# Access Compliance Report

## Public Rights-of-Way

### (Curb Ramps)

Intersection ID: 52444	Main Street: WILLOW_GREEN_PL	Cross Street: DOUBLE_OAKS_RD	Location:	N
ADA ID: 15FF1D3C5CB7	Ramp Type: PerpDiag	Initial Pass/Fail: Fail	Overall Compliance: No	Severity Score: 25

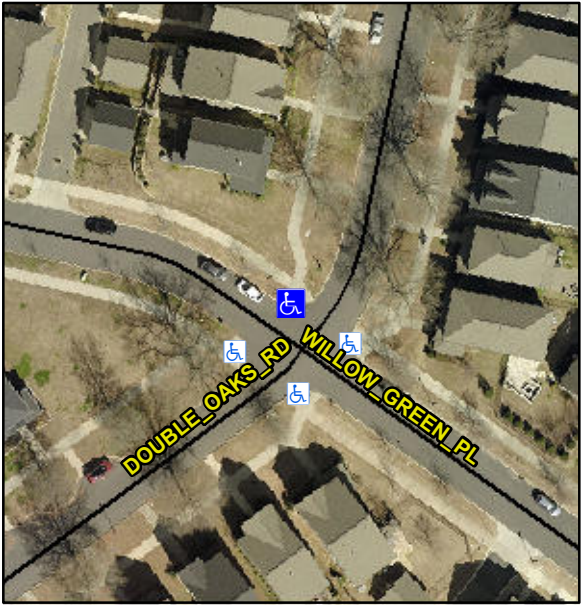
Codes/Mitigation Info/Possible Solution			Field Measurements/Component Compliance			
	Possible Solutions:		<b>Compliance</b>	<b>Description</b>	<b>Data</b>	
	<b>Remove &amp; Replace Curb Ramp With Two New Directional Ramps or Equivalent.</b>		<b>No</b>	<b>Ramp Length (in)</b>	<b>101.5</b>	<b>No</b>
			<b>Yes</b>	<b>Ramp Width (in)</b>	<b>71.5</b>	<b>No</b>
			<b>N/A</b>	<b>Flare Type LT</b>	<b>N/A</b>	<b>N/A</b>
			<b>N/A</b>	<b>Flare Slope LT (%)</b>	<b>N/A</b>	<b>N/A</b>
			<b>N/A</b>	<b>Flare Traversable LT?</b>	<b>N/A</b>	<b>N/A</b>
			<b>N/A</b>	<b>Landing Length (in)</b>	<b>N/A</b>	<b>N/A</b>
			<b>N/A</b>	<b>Landing Width (in)</b>	<b>N/A</b>	<b>N/A</b>
			<b>N/A</b>	<b>Landing Slope (%)</b>	<b>N/A</b>	<b>N/A</b>
			<b>N/A</b>	<b>Landing X Slope (%)</b>	<b>N/A</b>	<b>N/A</b>
			<b>N/A</b>	<b>Landing Curb? (Y/N)</b>	<b>N/A</b>	<b>N/A</b>
			<b>N/A</b>	<b>Shared Landing?</b>	<b>N/A</b>	
			<b>N/A</b>	<b>Gutter Ponding?</b>	<b>N/A</b>	<b>N/A</b>

**R304.2.2, R304.5.3**

**Remove & Replace Curb Ramp With Two New Directional Ramps or Equivalent.**
